AGENDA
City of Milton
Plan Commission
Tuesday, June 7, 2016
5:00 pm
MILTON CITY HALL
Council Chambers, 710 S. Janesville Street

To: City of Milton Plan Commission, Mayor Anissa Welch, and Common Council Members
From: Howard Robinson, Director of Public Works
Date: 06/07/2016
Subject: Discussion and Possible Action Regarding a Site Plan for Outdoor Seating at Fredricks Supper Club located at 118 Merchant Row.

To: City of Milton Plan Commission, Mayor Anissa Welch, and Common Council Members
From: Howard Robinson, Director of Public Works
Date: 06/07/2016
Subject: Discussion and Possible Action Regarding a Site Plan for Mini-Storage Warehouses at Pastorius Rentals, LLC located at 1135 S. Janesville Street.

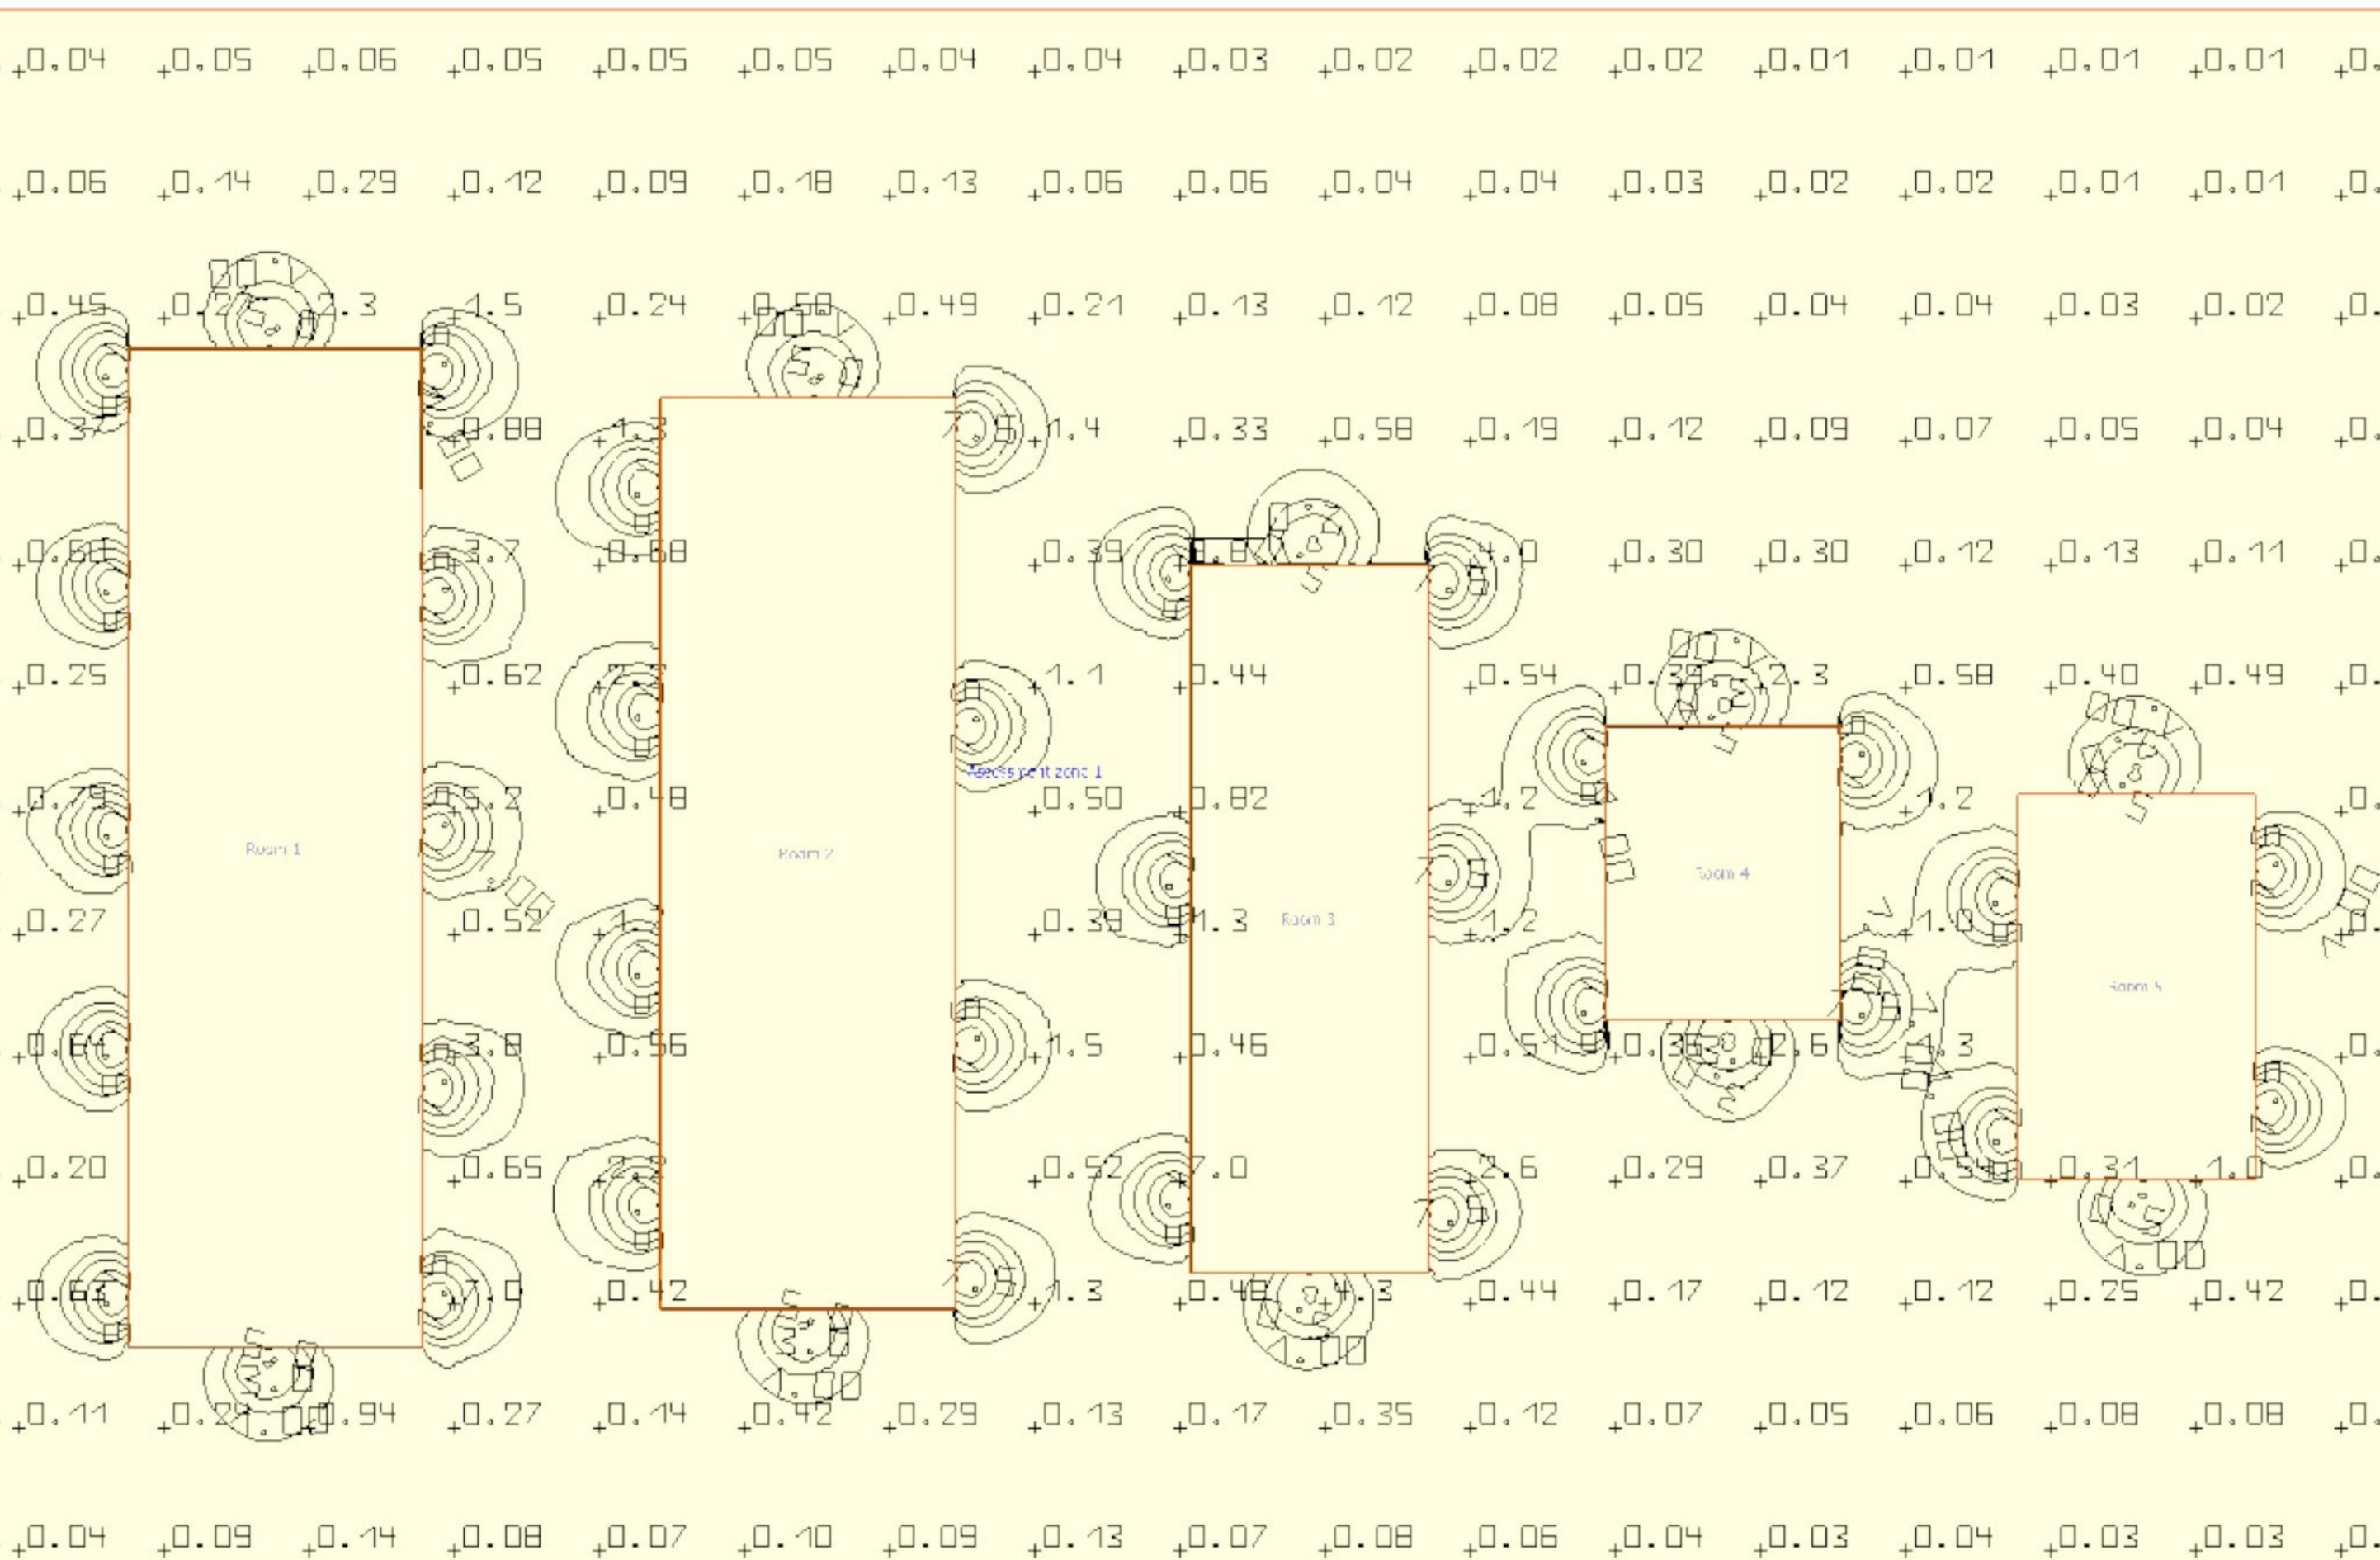
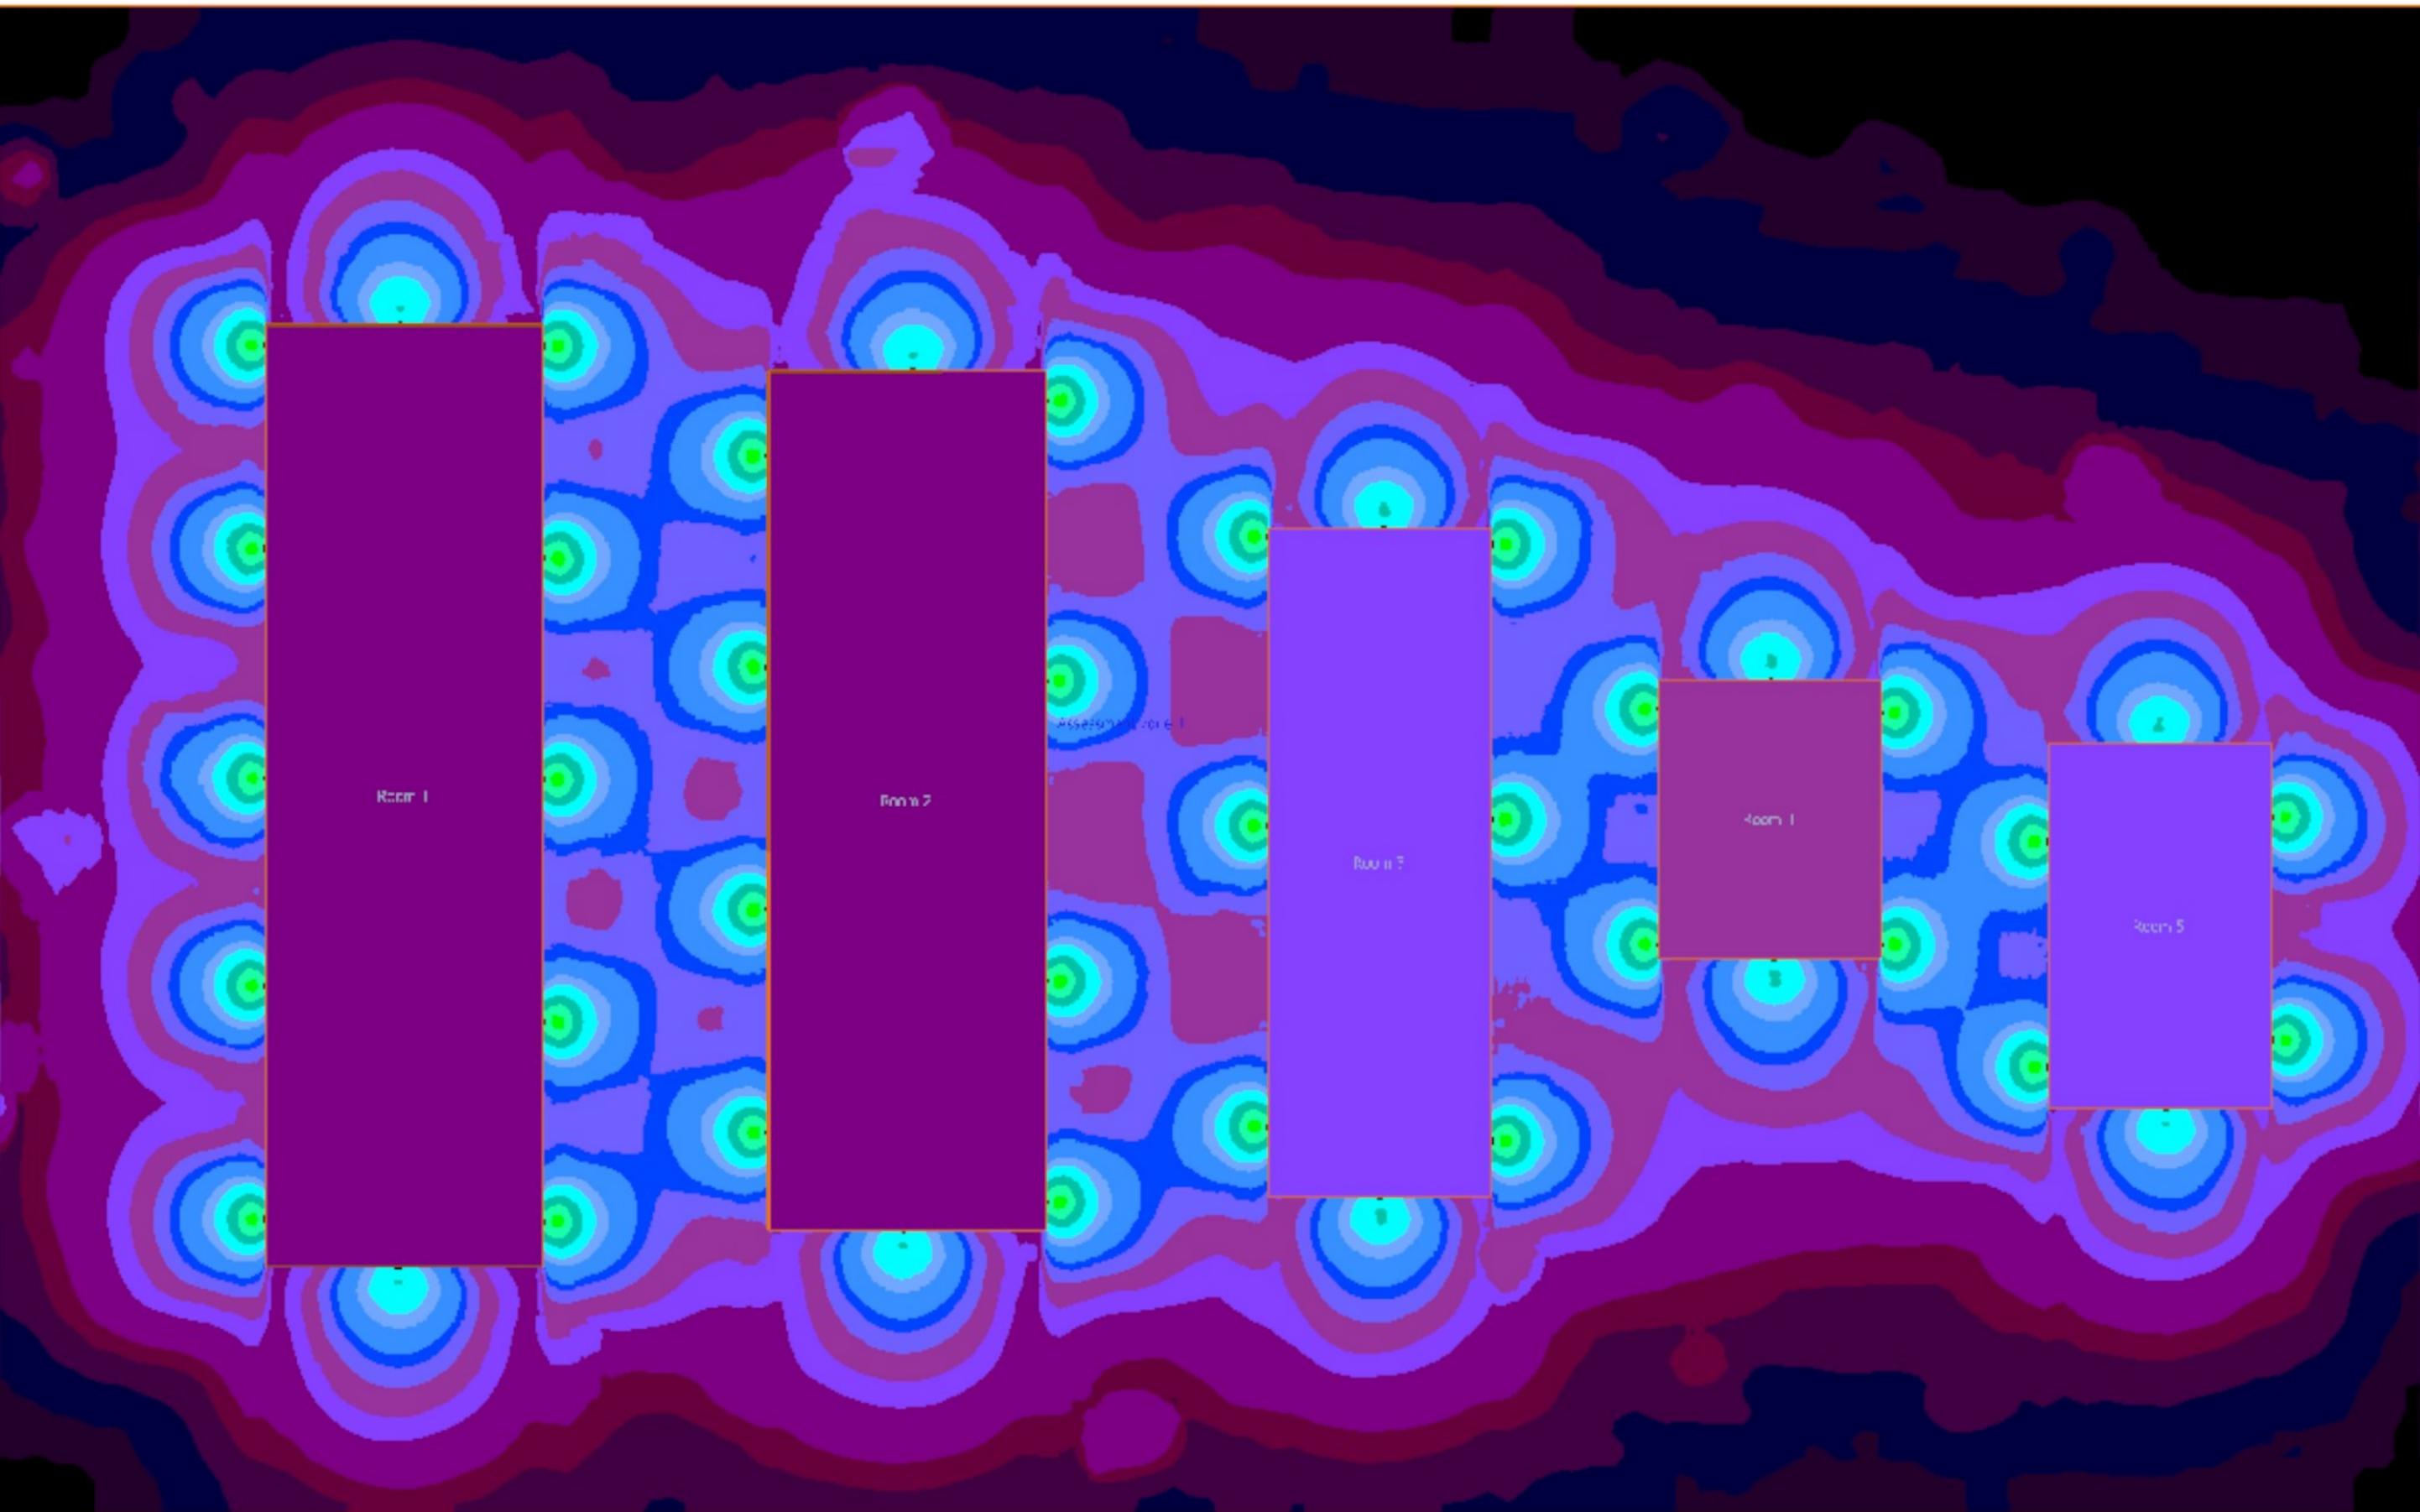
A site plan of the existing and proposed building layouts are included. The building setbacks meet city ordinance requirements. A landscape plan is provided; 30% greenspace is the minimum requirement and they have 35.1% so they have provided enough landscape. No outside storage is planned. An existing tree buffer line is on the side which meets the buffer requirement between them and the residential property to the west. No new points of ingress are needed. They share an existing driveway with Freedom Graphics. No outside trash containers are planned. Signs on the current building meet the sign ordinance. These are allowed to be on the front of the planned buildings if the owner desires to move them. A lighting plan has been submitted. The lights meet ordinance requirements. A grading and drainage plan is included. Our engineers from Baxter and Woodman have reviewed this. A maintenance plan is included for the storm water area. The maintenance plan needs to be recorded. Architectural drawings are included. The colors will match the current buildings as close as possible. The size of the buildings meet ordinance requirements. The state of Wisconsin also reviews the building plans for approval.

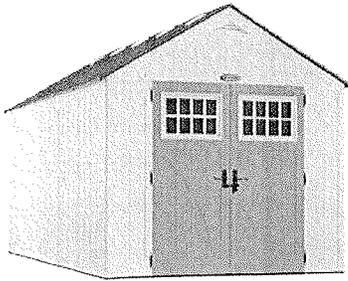
The apartment at 787 W. Sunset Drive has requested a site plan review for the construction of a shed behind the apartments. A shed of this type meets ordinance requirements. The apartment is larger than a 2 unit (duplex) so it is considered a commercial building. All commercial buildings require a site plan review. The shed is being constructed to store maintenance items such as a mower, etc. for care of the apartment grounds. The shed meets ordinance requirements. They received a site plan approval on December 1, 2015 for locating the shed near a different building. The shed is being moved to the west apartment due to utility concerns. Since it is on a different lot, a new site plan is being presented.

Recommendation is to approve the site plan request for the construction of a shed behind the apartments.
